LINK MT. BAKER APARTMENTS

RECOMMENDATION MEETING SDCI #3018722 MAY 8TH, 2018

RECOMMENDATION PACKET

OPTION 1. CEMENT PANEL SIDING FOR PRINCIPAL RESIDENTIAL ENTRY

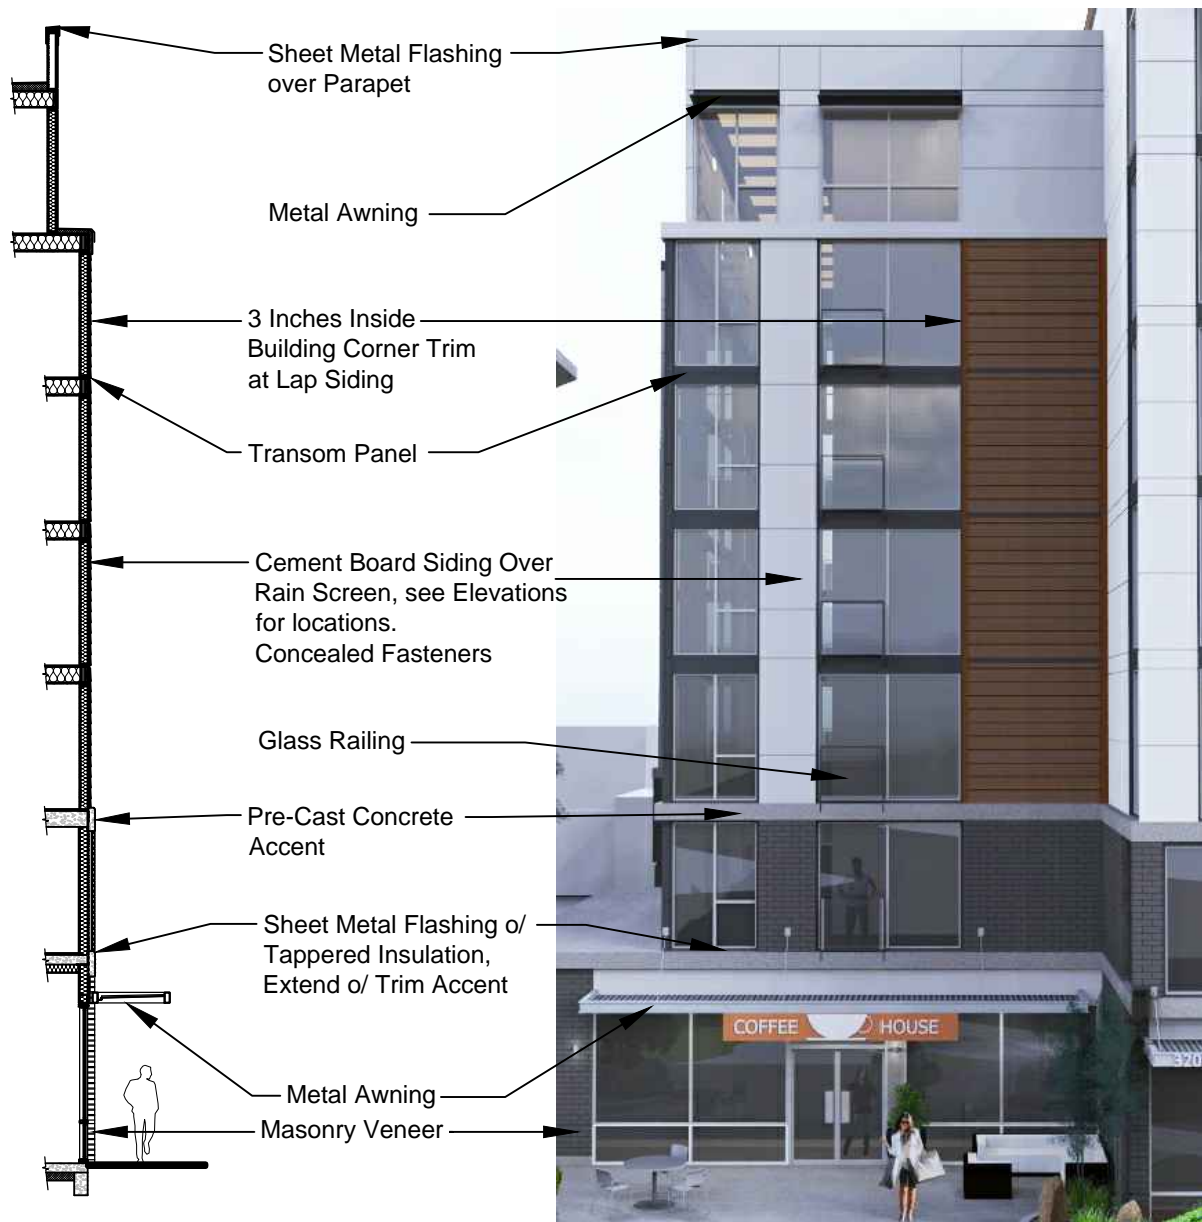
- a. Provide more information on the type of material proposed and material transitions. Articulate the relationship between the different materials and how the detailing strengthens the design concept.
- b. For the elevations, include more detailed material descriptions and specify color using callouts or a material legend. Clarify the type of cementitious
- c. Provide an alternate showing the use of brick as the cladding material for the principal residential entry "bay" as shown in the packet submitted dated February 7 2016. This design element was strongly supported by Staff, but that treatment needs to be reflected also as the podium level in order to satisfy the Boar's recommendation that important element 'read' singularly.
- d. Potential alternate may be to extend the second story base glazing proposed for the podium up through the residential entry bay upper volume.

The two options with using cladding material for the principal residential entry are shown on page 10: Cement Board panel as Option 1, and Brick clad as Option 2.

The cement board panel option is the preferred option. The projection of the entry element with the light colored cement board creates a strong visual image. That image reinforces the entry as a contrasting building element. The brick clad version visually recedes, which contradicts the intent of emphasizing the location of the building entrance.

FLOOR:
1ST FLOOR PLAN

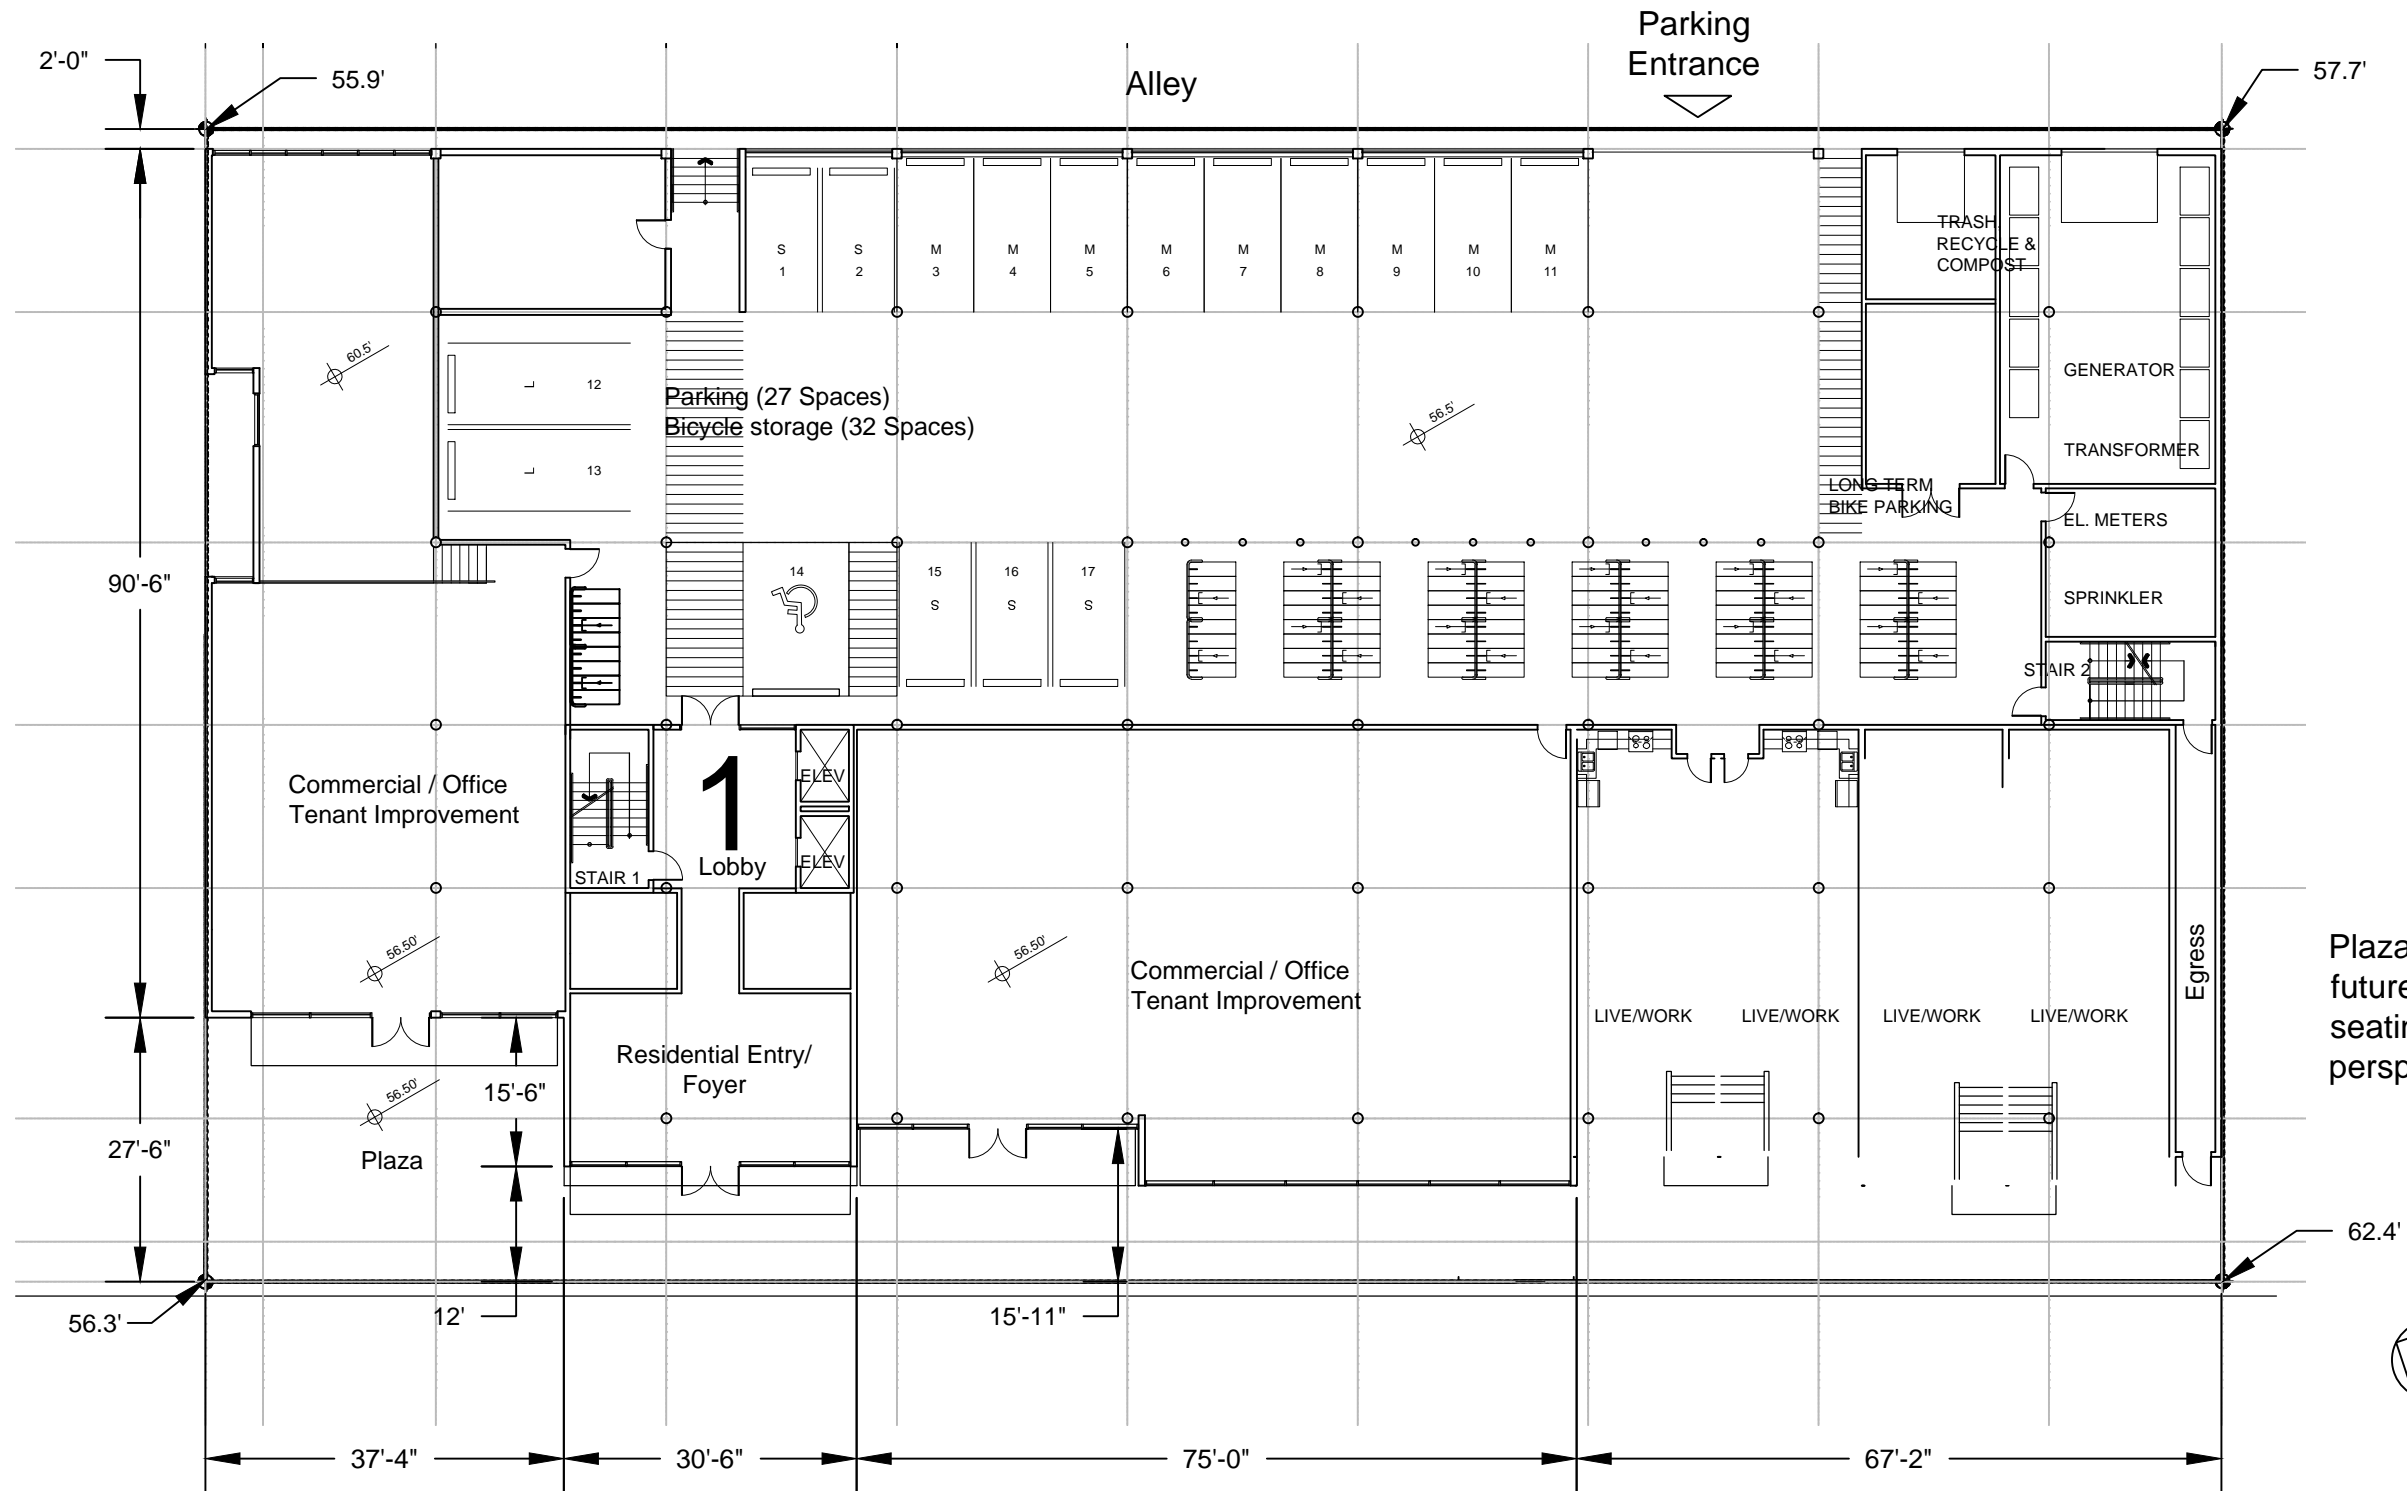
- a. The DRB also discussed wayfinding for the site and agreed vehicular parking and loading for the commercial spaces should be clarified to indicate how future retail users will access parking. Provide information about wayfinding and how parking and loading for the commercial/retail spaces will clear to visitors ((DC3-B.1)
- b. Describe the program of the plaza space; while developing the design consider outdoor seating (DC3-B.2)

Plaza program, including future retails with outdoor seating area shown on perspectives.

Study of proposed North facade with the proposed facade of neighboring building on Hanford street (also currently under development)

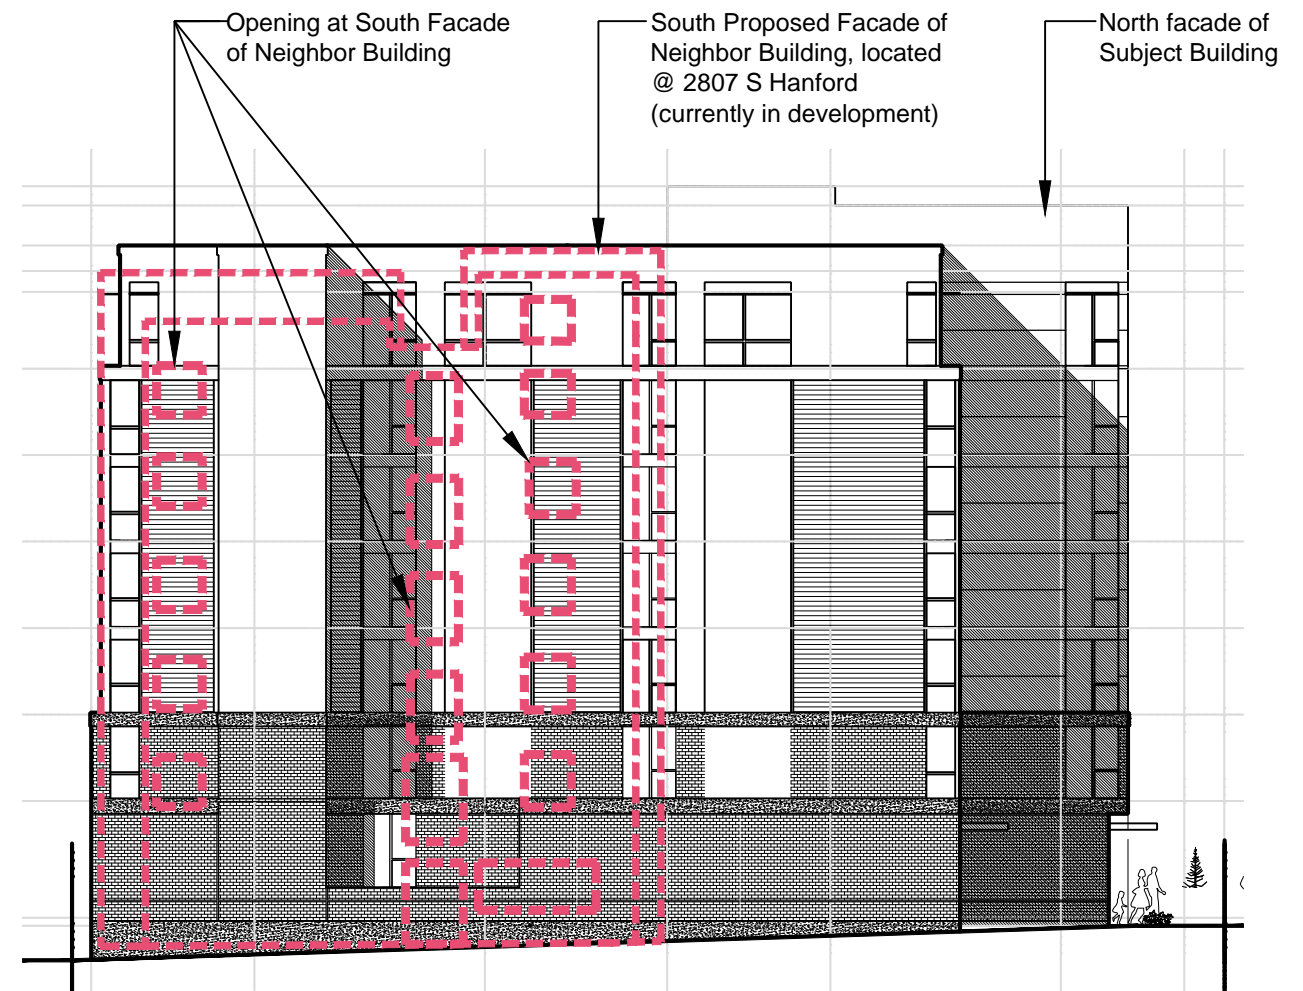
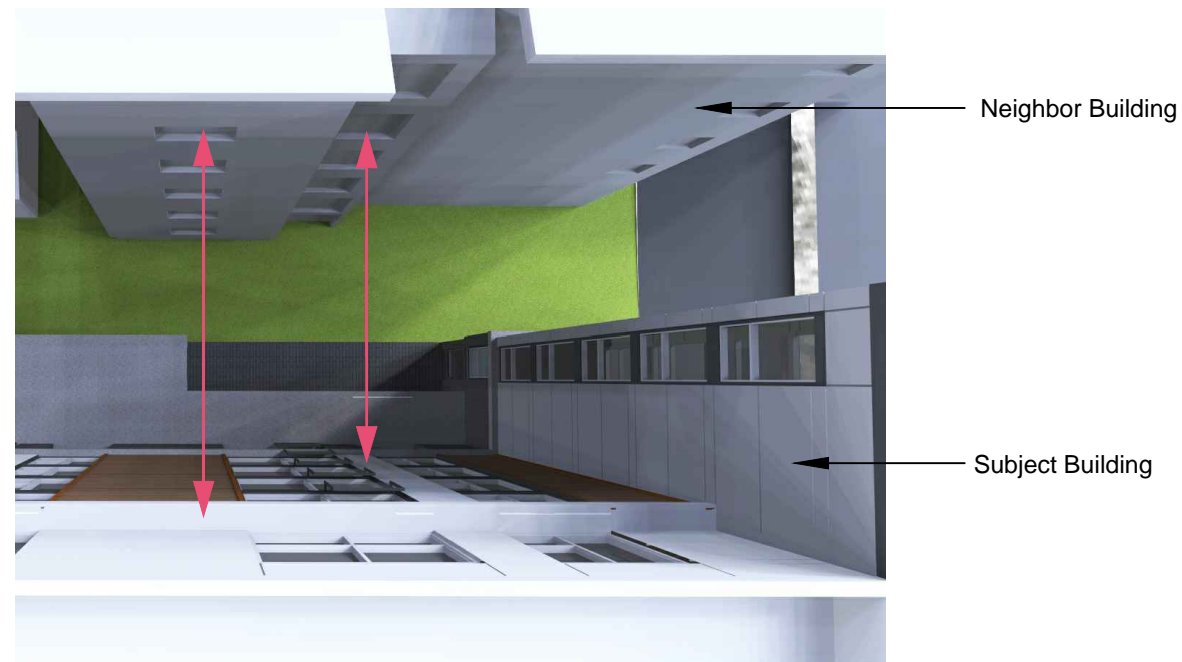
- d. There is a current proposal for the abutting property to the north (3025190). Address how the design responds to this proposal and potential privacy impacts. Include perceptive views documenting the relationship between the two projects and include a window mapping study. Refine the design as needed to work well for both the existing and future condition.

Setbacks have allowed for the same number of windows relevant to the previously approved design from the DRB. Window groupings have changed to respond to modified unit space plans and to create common proportions between windows and blank walls. See Elevation sheets for further design development. Further information, including window study for additional proposed project to the north, see additional page G-15. The North and South elevations have a revised cadence that does not interfere with the proposed project to the North. See page 8.
